GREAVES SUBDIVISION FILING NO. 1

A REPLAT OF LOT 13, WILDWOOD RANCH ESTATES FILING 7

PCD FILE NO: VR243

GREAVES SUBDIVISION
FINAL PLAT
For:
ALAN & JUDITH GREAVES

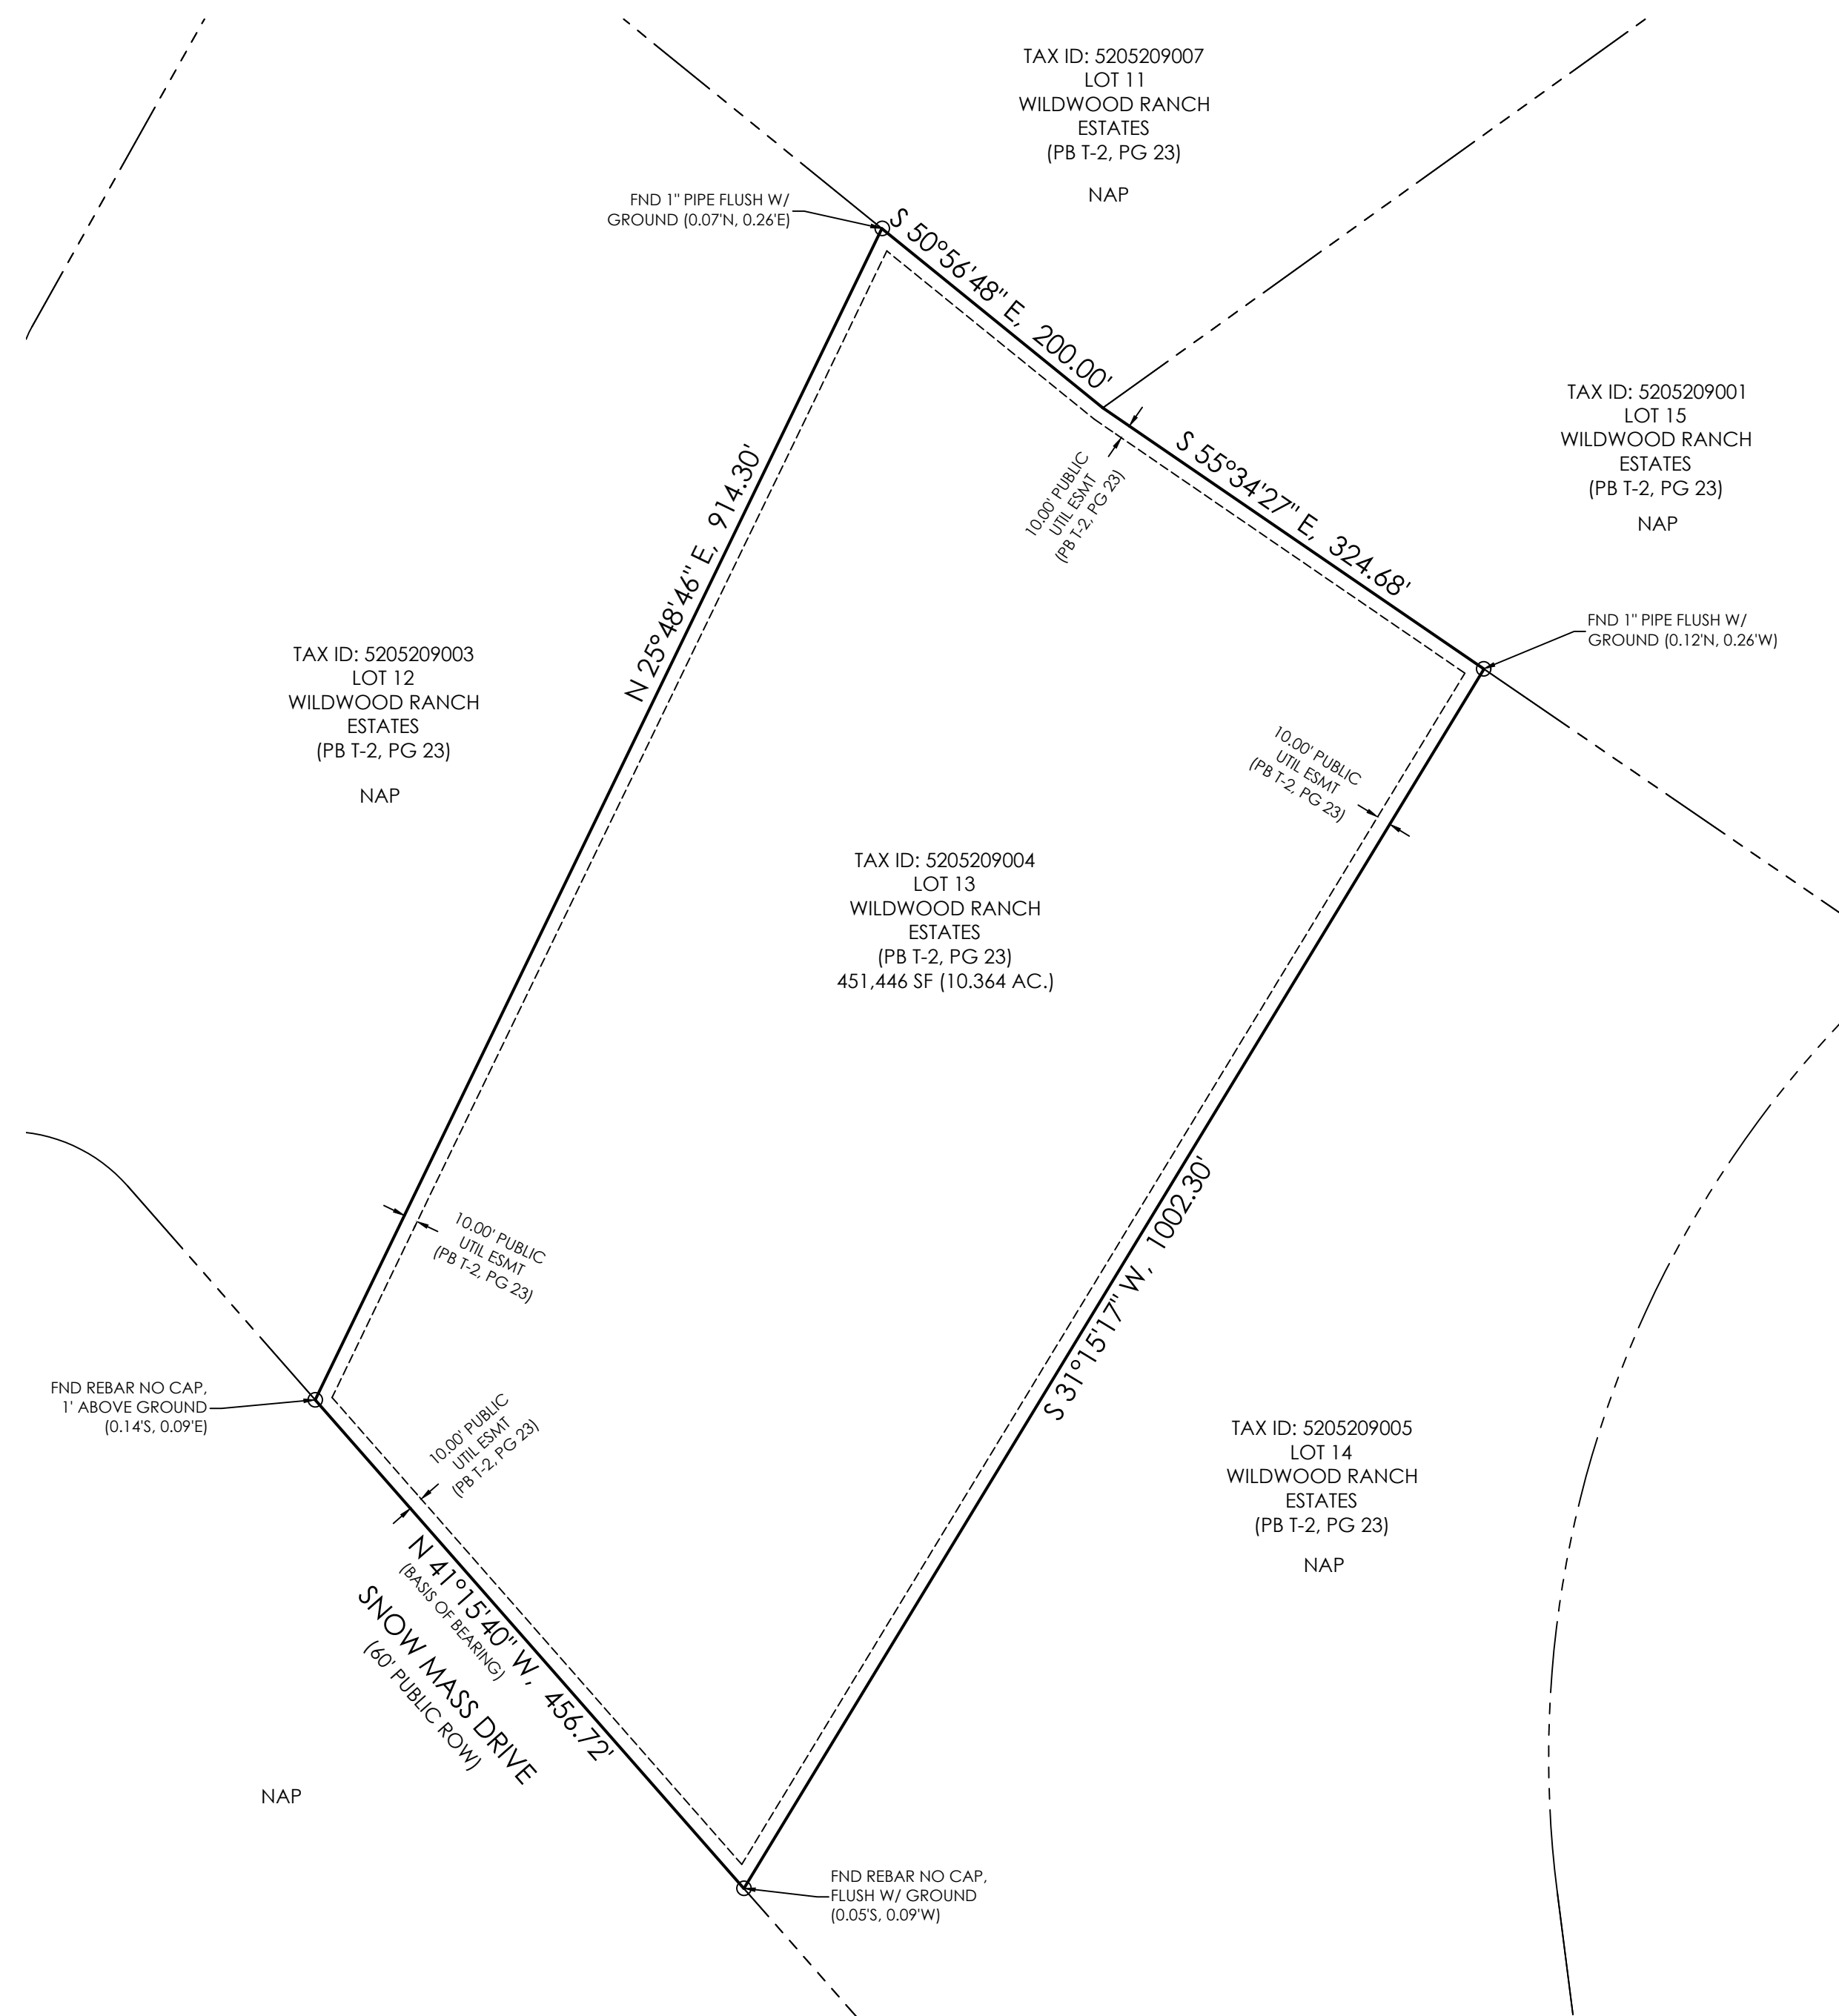
ABSORPTION FIELD MUST BE LOCATED A MINIMUM OF 100 FEET FROM ANY WELL, INCLUDING THOSE ON ADJACENT PROPERTIES. ABSORPTION FIELDS MUST ALSO BE LOCATED A MINIMUM OF 50 FEET FROM ANY DRAINAGES, FLOODPLAINS, OR PONDED AREAS AND 25 FEET FROM DRY GULCHES." PLEASE ADD NOTE IN REGARD TO ON-SITE WASTEWATER SYSTEMS.
